# TRANSIT EFFECTIVENESS PROJECT Final Environmental Impact Report

Volume 2 – Chapter 8: Responses to Comments

**City and County of San Francisco Planning Department  
Case No. 2011.0558E**

Changes from the DEIR text are indicated by a dot (●) in the left margin.

(New) FIGURE 8a - TTRP.L TARAVAL STREET AND 44TH AVENUE IMPROVEMENTS

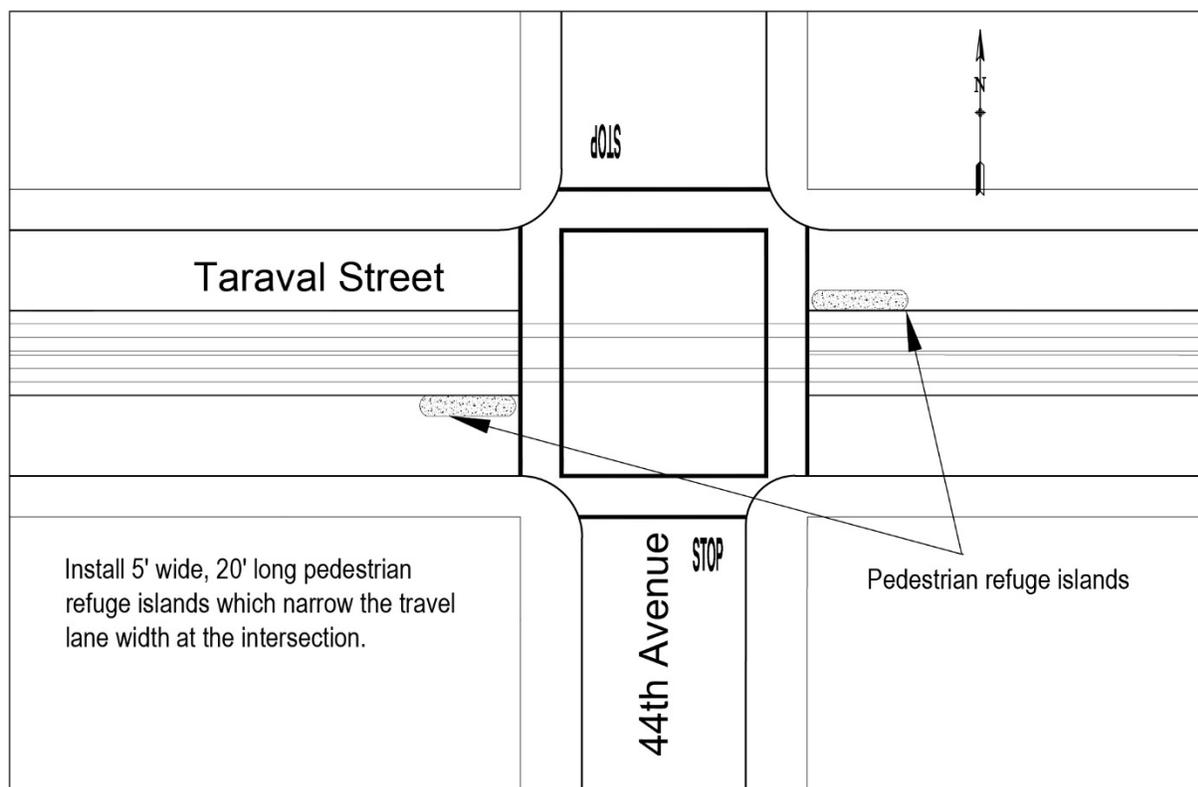
**Pedestrian Improvements (Moderate):** On Taraval Street at 44<sup>th</sup> Avenue, a five-foot-wide, 20-foot-long pedestrian refuge island would be added between the mixed-flow travel lane and the transit-only lane in the inbound and outbound directions. Figure 8a shows the proposed change.

(New) FIGURE 8c - TTRP.L TRAFFIC CALMING AT TARAVAL STREET AND 42ND AVENUE EXPANDED ALTERNATIVE

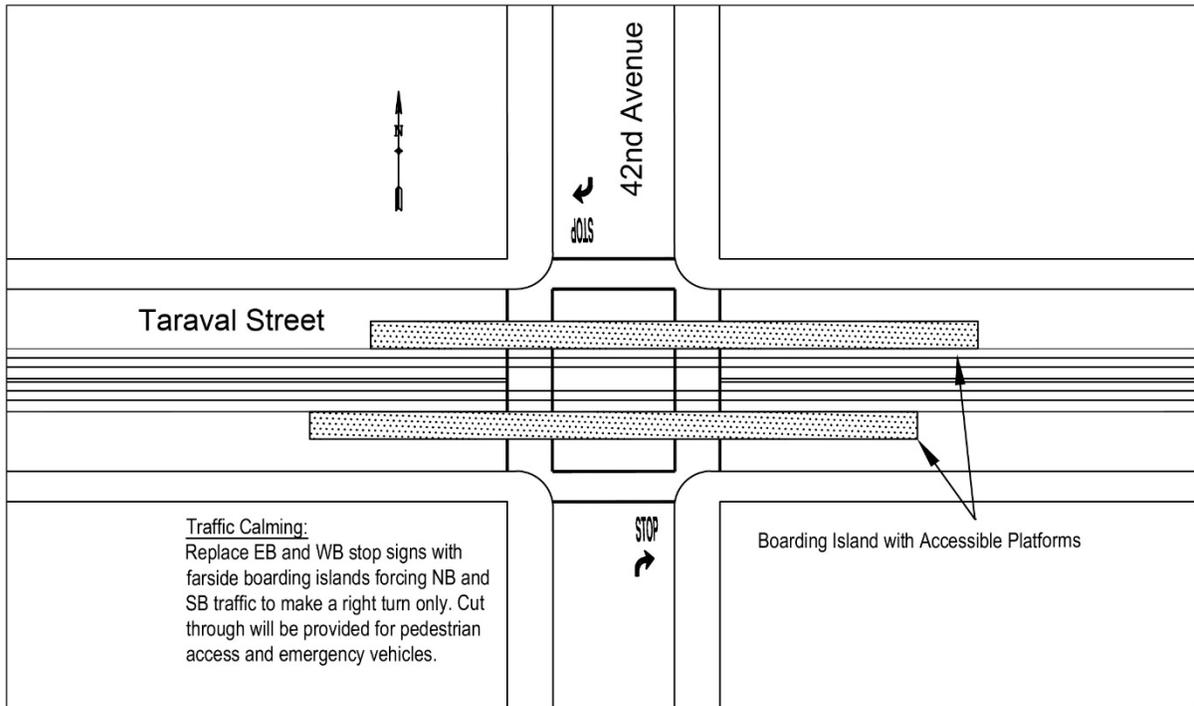
Ulloa Street/15<sup>th</sup> Avenue: A traffic calming, channelizing island would be added in the intersection which would eliminate all through movements forcing a right turn only for all directions, except for southbound traffic, which would be required to make either a right turn or left turn. Figure 8b shows the proposed change for this intersection.

(New) FIGURE 8d - TTRP.L EXPANDED ALTERNATIVE

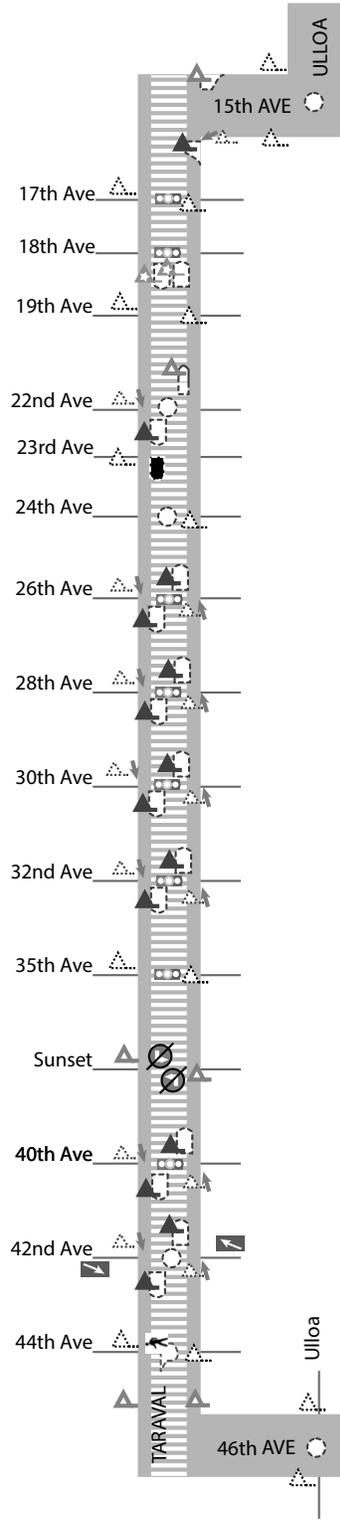
Figure 8d shows the TTRP.L Expanded Alternative and narrative text describes the difference between the Moderate and Expanded Alternatives.

(Revised) FIGURE 11 - TTRP.5 EXPANDED ALTERNATIVE

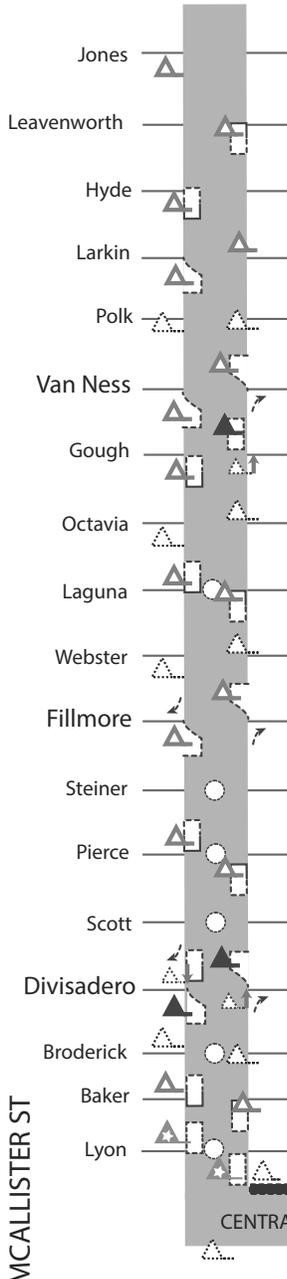
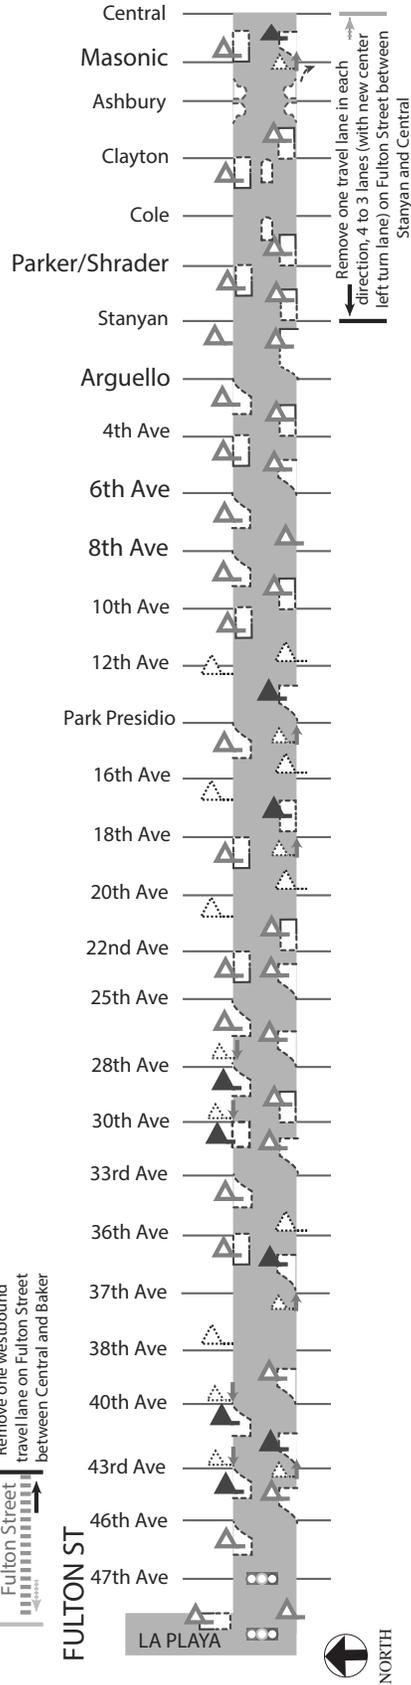
Figure 11: TTRP.5 Expanded Alternative on EIR p. 2-128 has been revised to show that under the Moderate and Expanded Alternatives new inbound and outbound stops would be located at McAllister and Lyon streets, and that one westbound travel lane on Fulton Street (between Central Avenue and Baker Street) would be removed as part of the Expanded Alternative only. Additionally, text on the figure describing how the Moderate Alternative would differ from the Expanded Alternative has been revised to indicate the following: the existing inbound and outbound bus stops at McAllister and Divisadero streets would remain nearside and would be expanded, and right-turn pockets would not be added to McAllister Street at Divisadero Street. Revised Figure 11 is shown on the following page.

(Revised) FIGURE 23 - TTRP.30 EXPANDED ALTERNATIVE

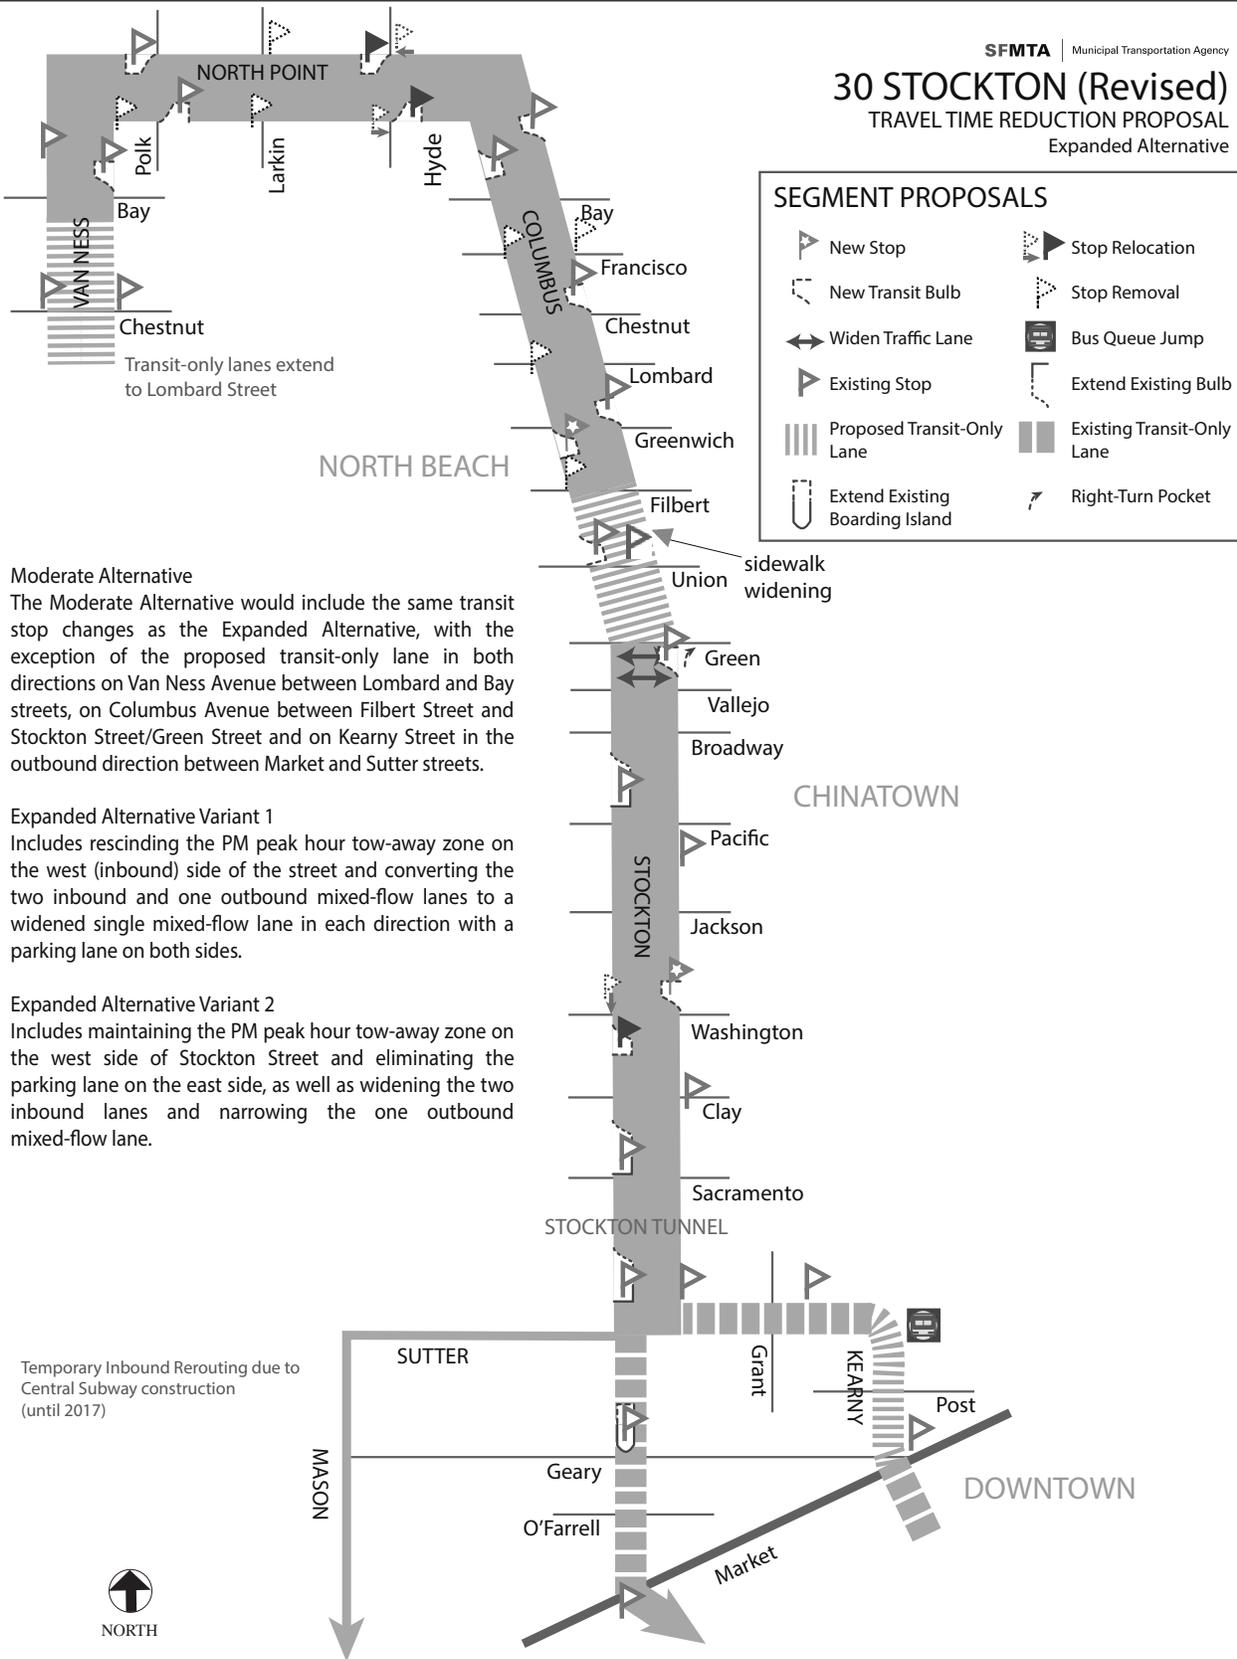
Figure 23: TTRP.30 Expanded Alternative on EIR p. 2-160 has been revised to show that under the Moderate and Expanded Alternatives sidewalk widening would occur on the east side of Columbus Avenue on the entire block between Union and Powell streets. Revised Figure 23 is shown on the following page.

(New) FIGURE 23a - TTRP:71\_1 EXPANDED ALTERNATIVE

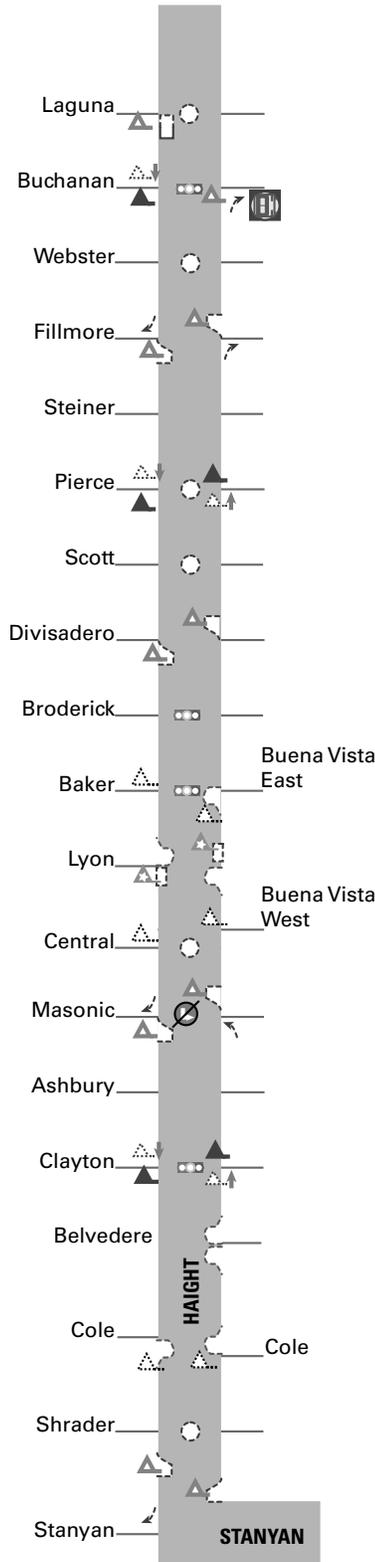
Figure 23a shows TTRP.71\_1 Expanded Alternative and describes the differences between the Moderate and Expanded Alternatives. Please see information and additional graphics illustrating the TTRP.71\_1 project at the SFMTA Web site, online at <http://www.sftfep.com>.

(New) FIGURE 8a - TTRP.L TARAVAL STREET AND 44TH AVENUE IMPROVEMENTS

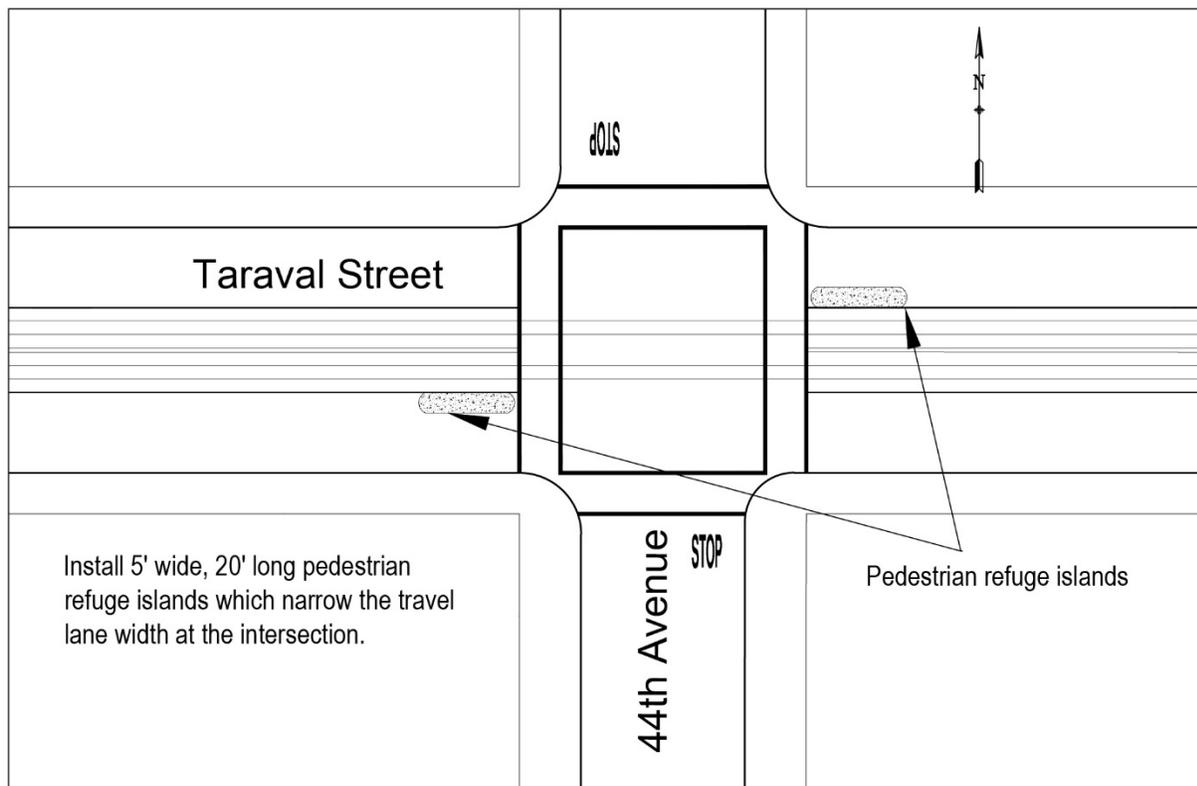
flow travel lane and the transit-only lane in the inbound and outbound directions. Figure 8a shows the proposed change.

(New) **FIGURE 8b - TTRPL TRAFFIC CALMING AT ULLOA STREET AND 15TH AVENUE EXPANDED ALTERNATIVE**

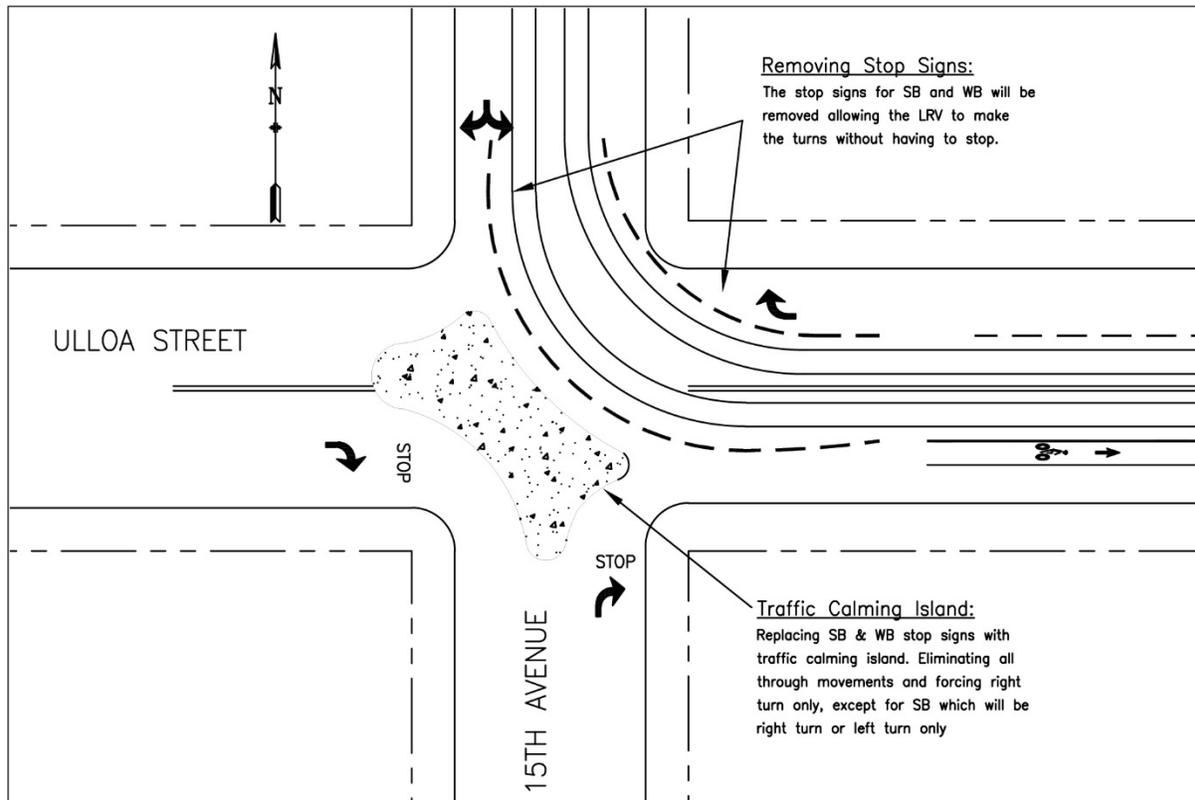
Ulloa Street/15<sup>th</sup> Avenue: A traffic calming, channelizing island would be added in the intersection which would eliminate all through movements forcing a right turn only for all directions, except for southbound traffic, which would be required to make either a right turn or left turn. Figure 8b shows the proposed change for this intersection.

(New) FIGURE 8c - TTRP.L TRAFFIC CALMING AT TARAVAL STREET AND 42ND AVENUE EXPANDED ALTERNATIVE

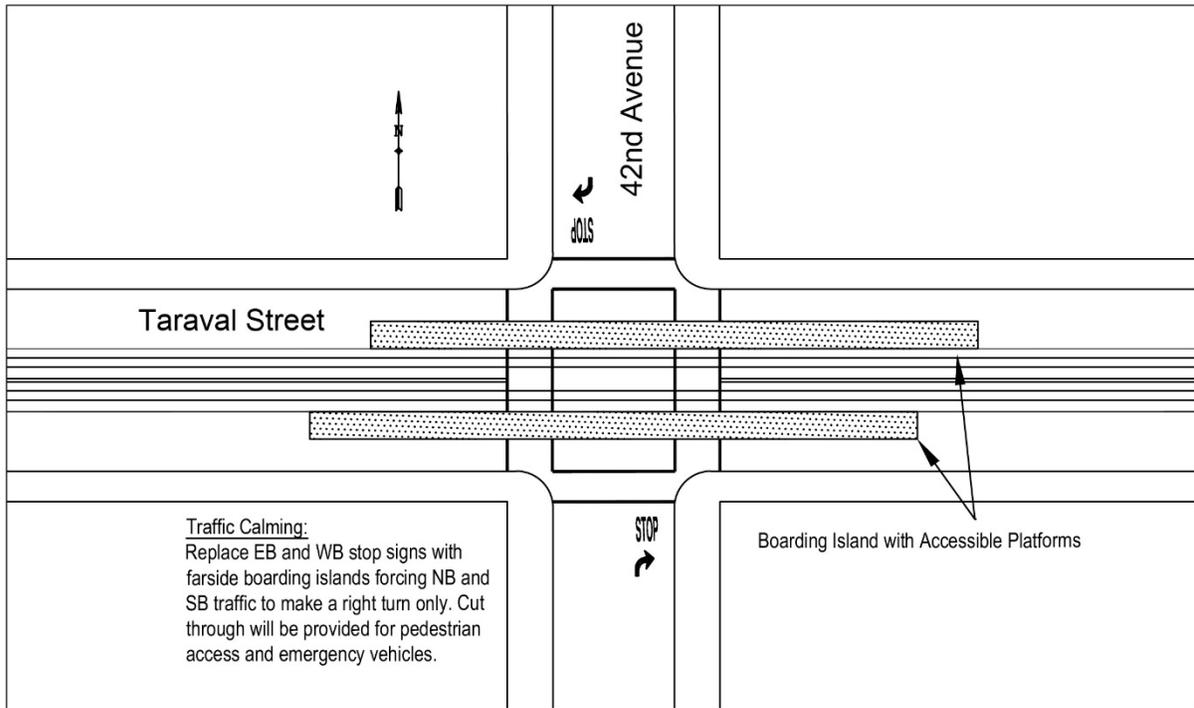
Taraval Street/42<sup>nd</sup> Avenue: On Taraval Street, two 9-foot-wide, 150-foot-long transit boarding islands would be installed and extended through the intersection to serve both inbound and outbound directions. Right-turn only restrictions would be added on 42<sup>nd</sup> Avenue for northbound and southbound traffic. The islands would be designed with a low profile cut-out in the middle that would be wide enough for emergency vehicles to continue through the intersection. Figure 8c shows the proposed change.

(New) FIGURE 8d - TTRP.L EXPANDED ALTERNATIVE

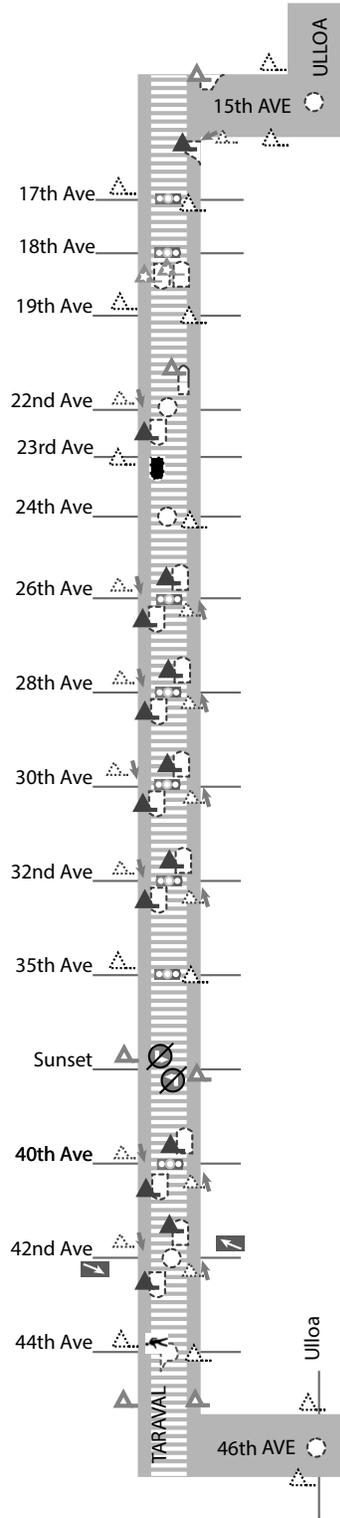
Figure 8d shows the TTRP.L Expanded Alternative and narrative text describes the difference between the Moderate and Expanded Alternatives.

(Revised) FIGURE 11 - TTRP.5 EXPANDED ALTERNATIVE

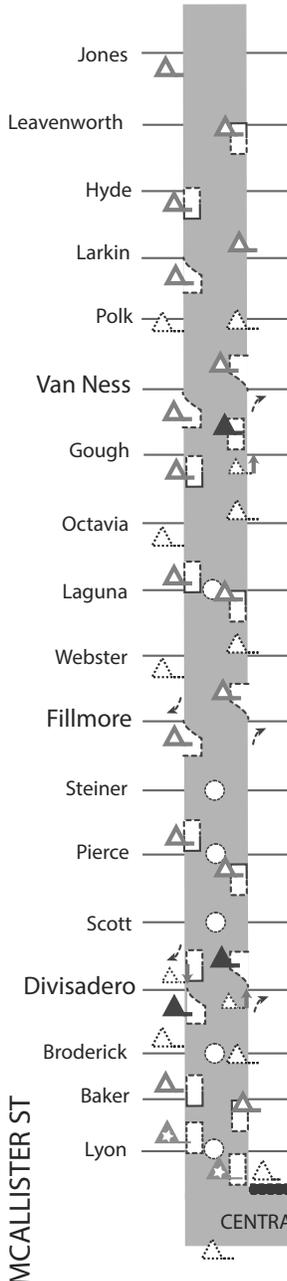
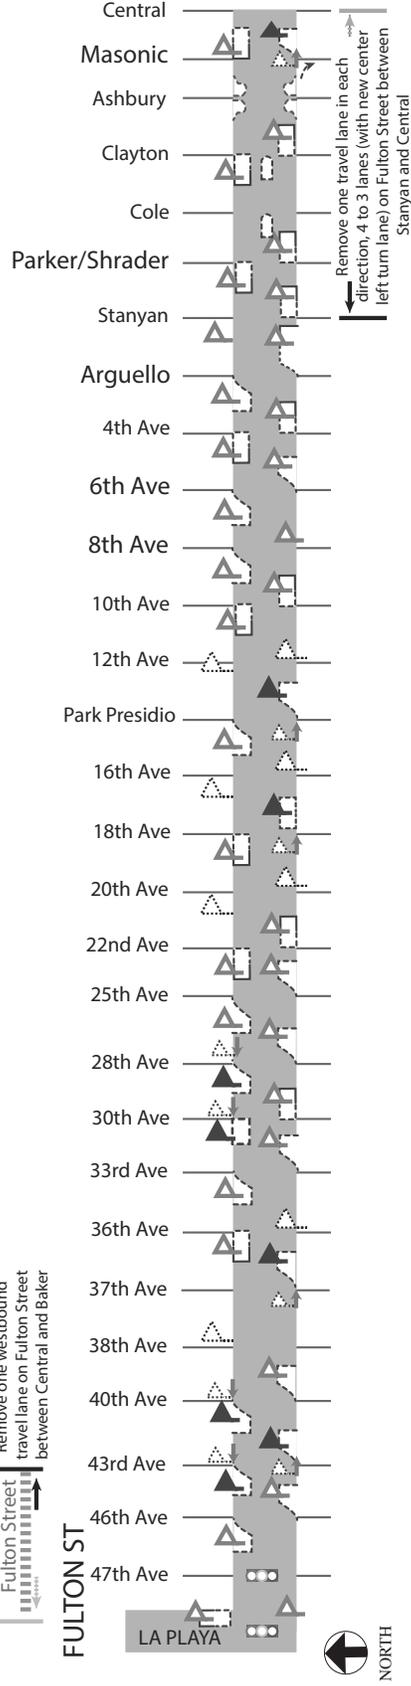
Figure 11: TTRP.5 Expanded Alternative on EIR p. 2-128 has been revised to show that under the Moderate and Expanded Alternatives new inbound and outbound stops would be located at McAllister and Lyon streets, and that one westbound travel lane on Fulton Street (between Central Avenue and Baker Street) would be removed as part of the Expanded Alternative only. Additionally, text on the figure describing how the Moderate Alternative would differ from the Expanded Alternative has been revised to indicate the following: the existing inbound and outbound bus stops at McAllister and Divisadero streets would remain nearside and would be expanded, and right-turn pockets would not be added to McAllister Street at Divisadero Street. Revised Figure 11 is shown on the following page.
